The Zoning and Site Development Department recommends approval of the MPUD Master Planned Unit Development, subject to the attached rezoning conditions of approval, Petition No. 6866.

Approved Staff Recommendation with Revised Conditions

**CROSS PARK
MASTER PLANNED UNIT DEVELOPMENT
CONDITIONS OF APPROVAL
REZONING PETITION NO. 6866**

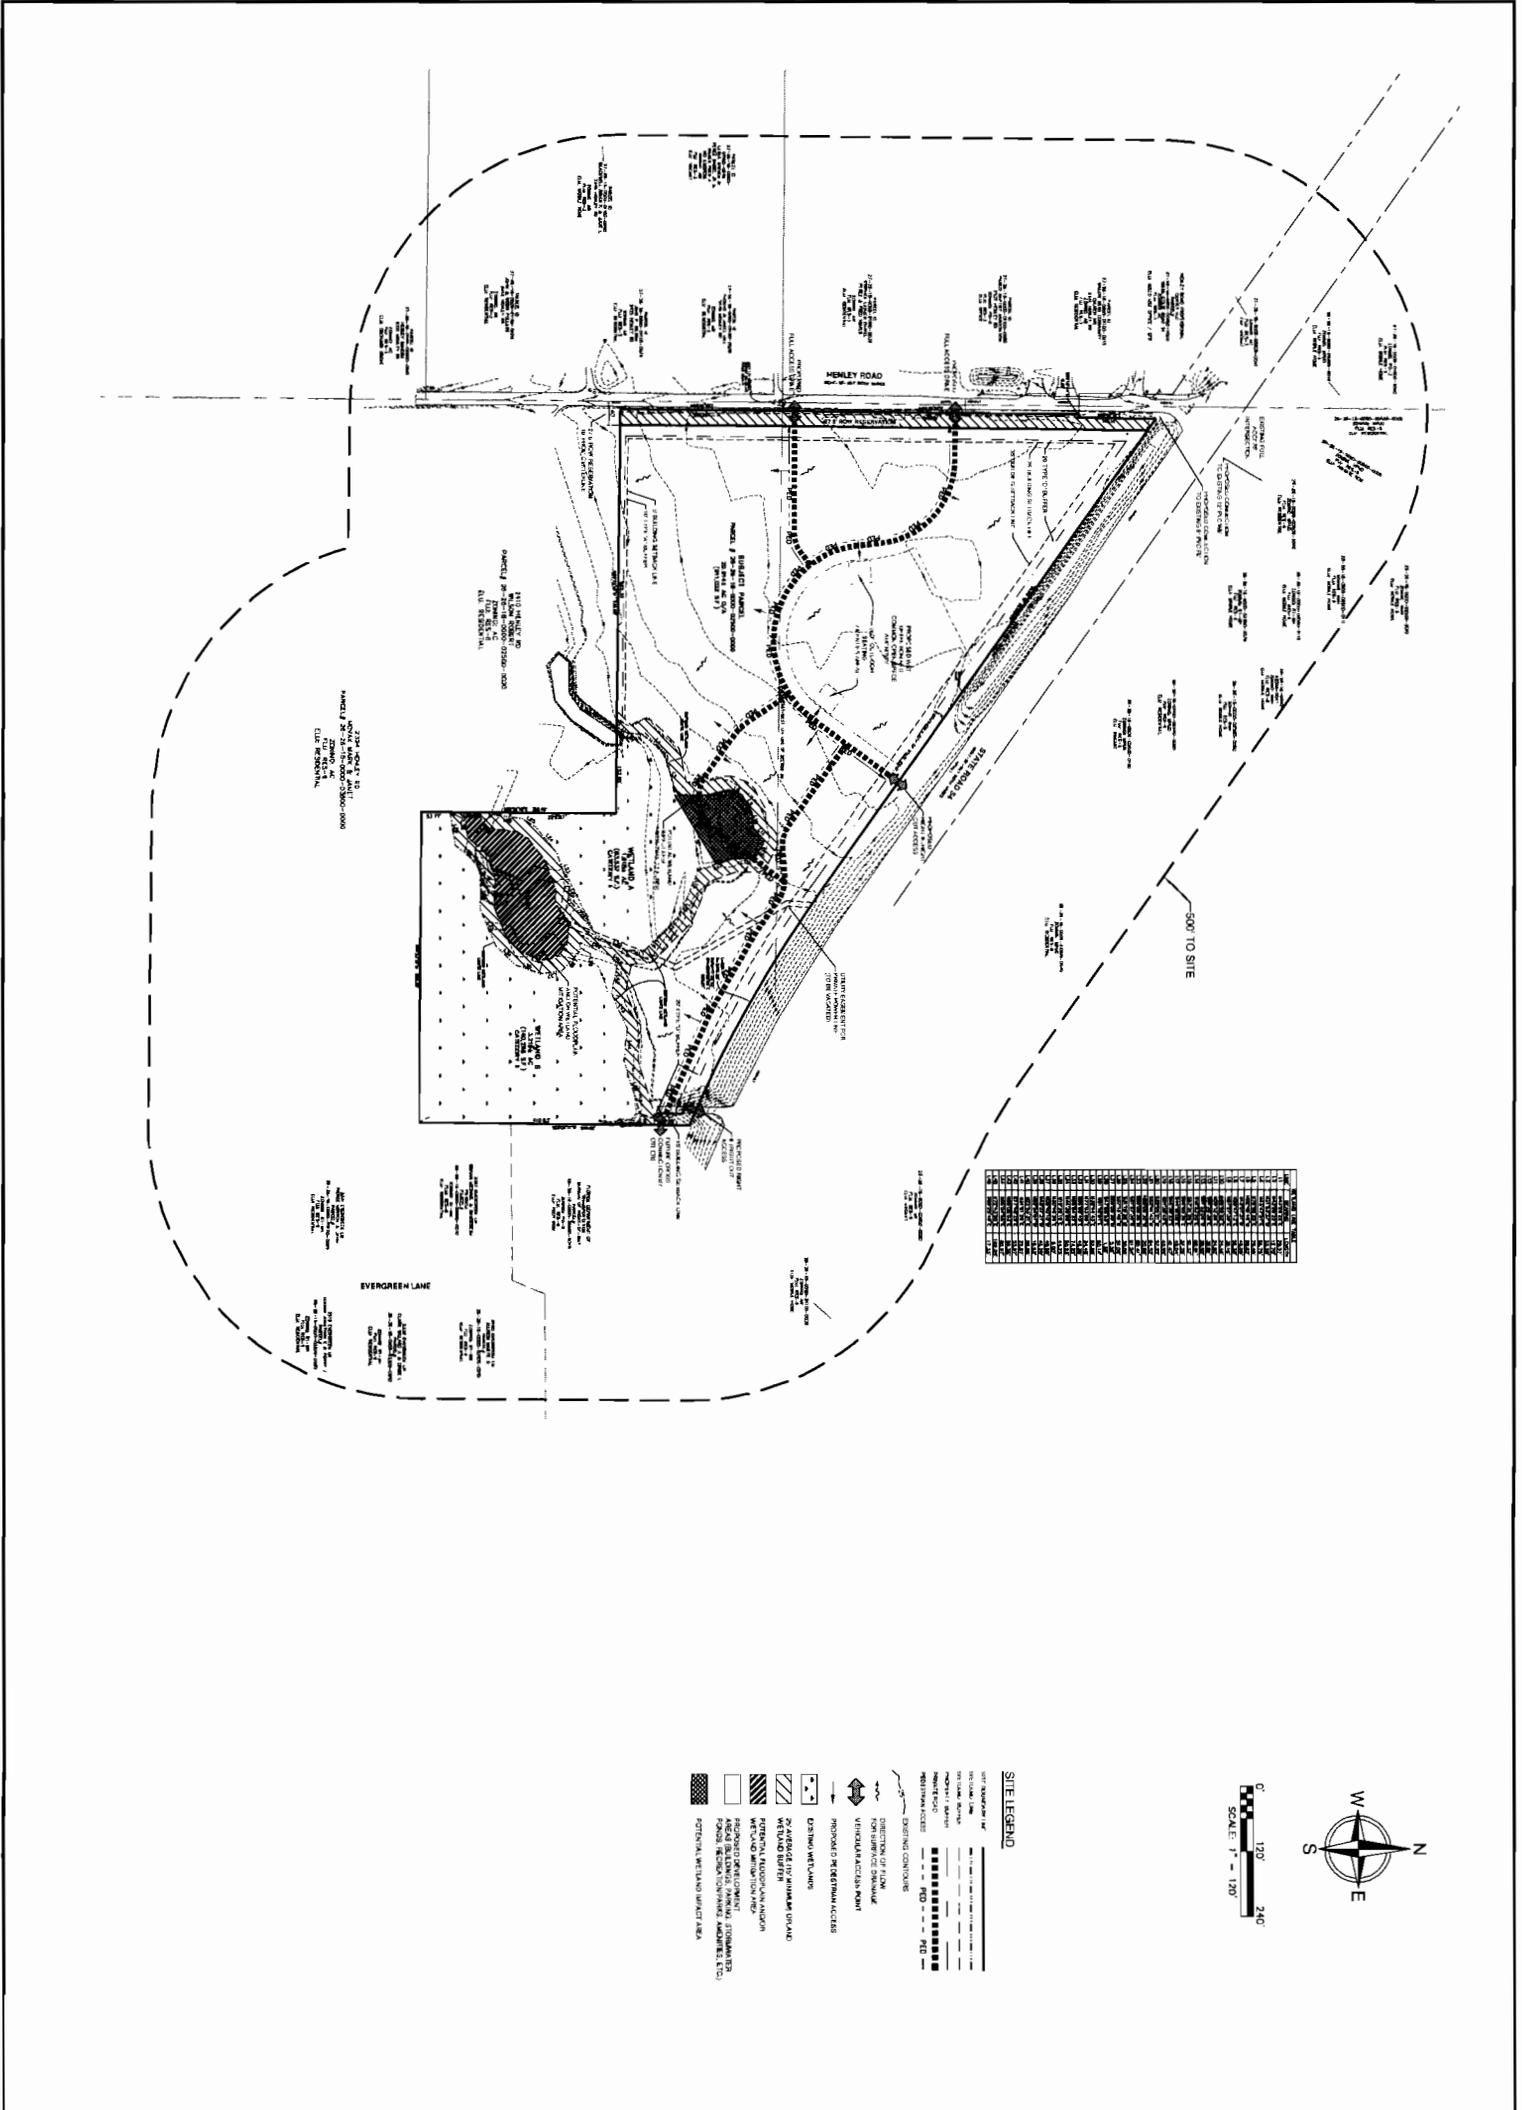
- a. Revise the master plan to remove the second sentence from No. 1 under Landscape Buffer Notes.
 - b. Revise the master plan under Minimum Perimeter Setbacks to show setback labels as "front," "side," and "rear" (not north, south, east, and west).

- c. Revise the master plan, Sheet 2, to indicate the correct right-of-way conveyance for Henley Road to be 67.5 feet from the centerline of construction, subject to Condition No. 18 below.

- d. Revise the master plan to show a 15-foot buffer (25 feet if there is an abutting building) on the southern portion of the property.
